## ROTARY PARK - REFER MR JIM CASE

CALOUNDRA ROAD  
ACCESS TO PROPOSED ROTARY PARK

This Department would not object to an access to the proposed park subject to the following conditions.

ACCESS

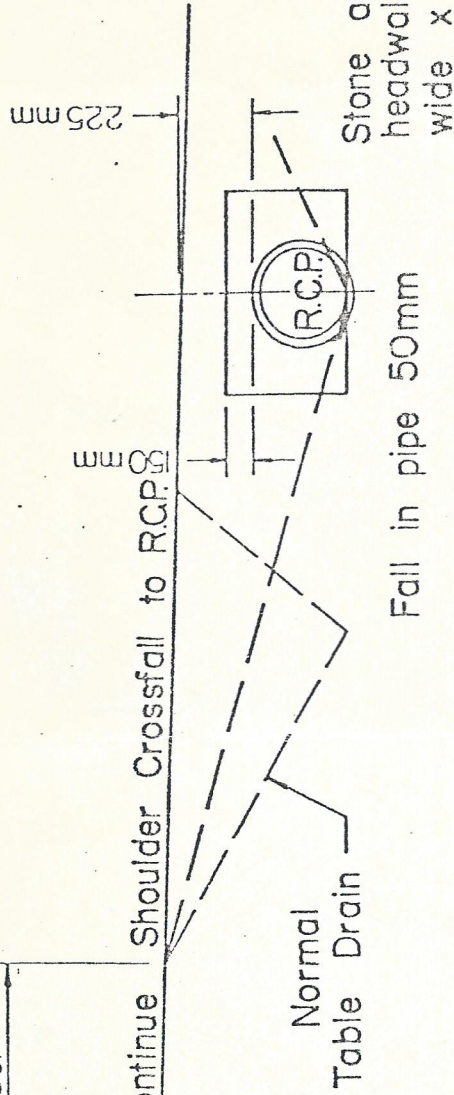
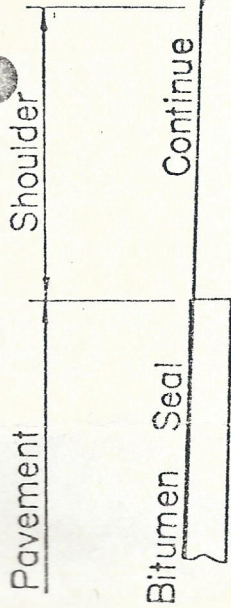
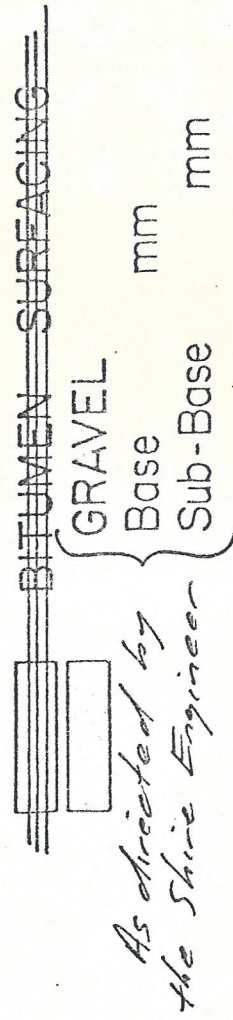
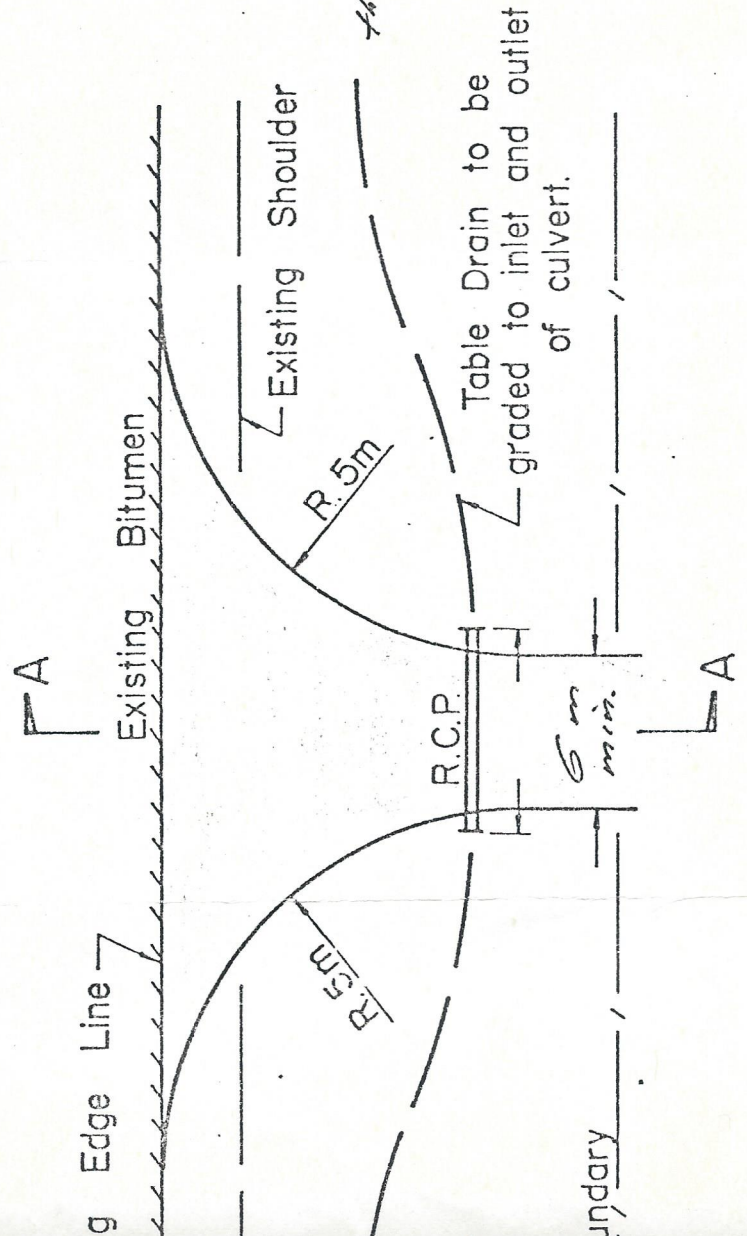
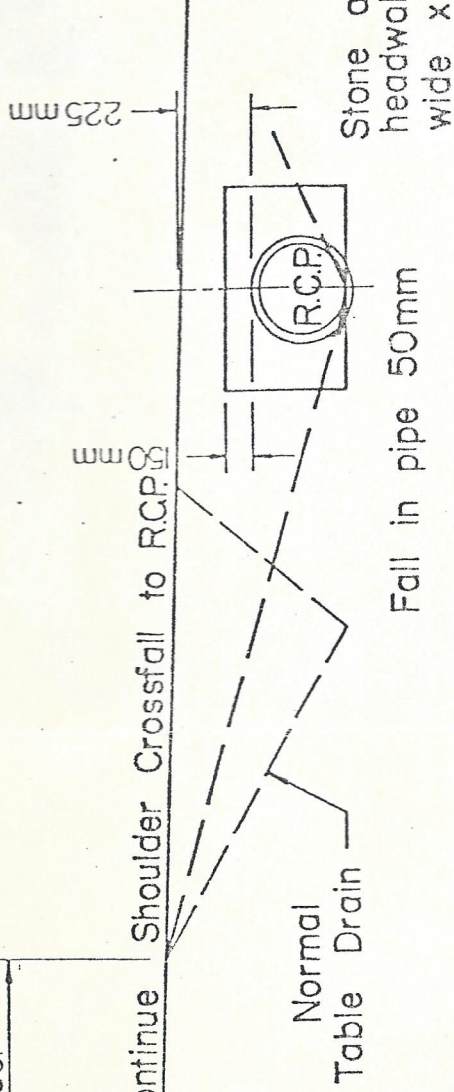
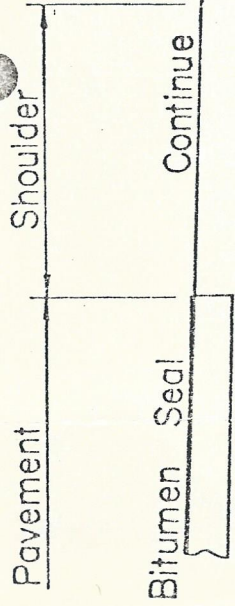
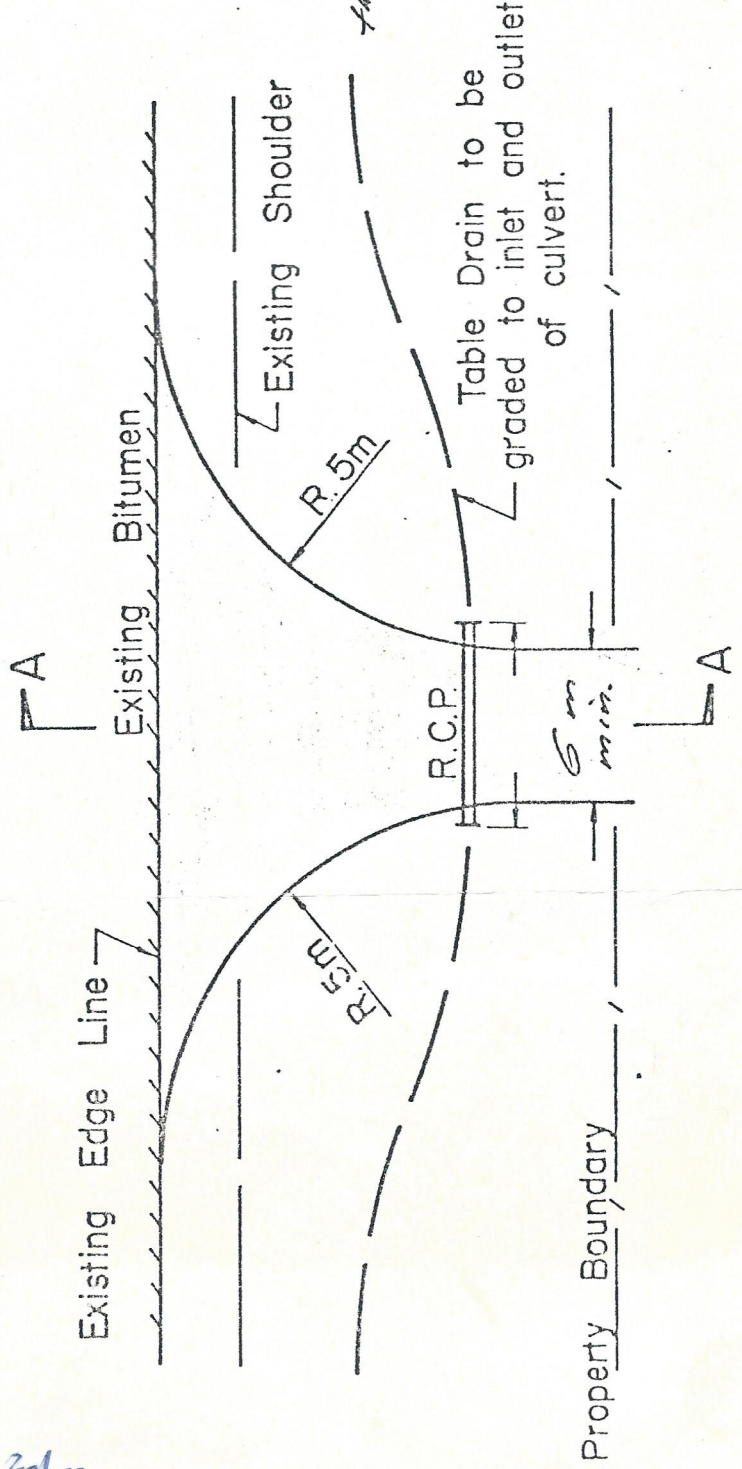
1. The access should be located as near as possible to the eastern boundary of the area.
2. The access should be constructed as per the attached drawing for Access (Type 1) as a minimum standard. The low standard of access will be acceptable as it is planned to widen Caloundra Road to four lanes within three years in conjunction with the Caloundra Bypass.
3. All work within the road reserve must be carried out by your Council.
4. It is assumed that, the access to the park will replace the existing access to the Australian

Rules Football Club as only one access will be permitted from Caloundra Road to R.1000.
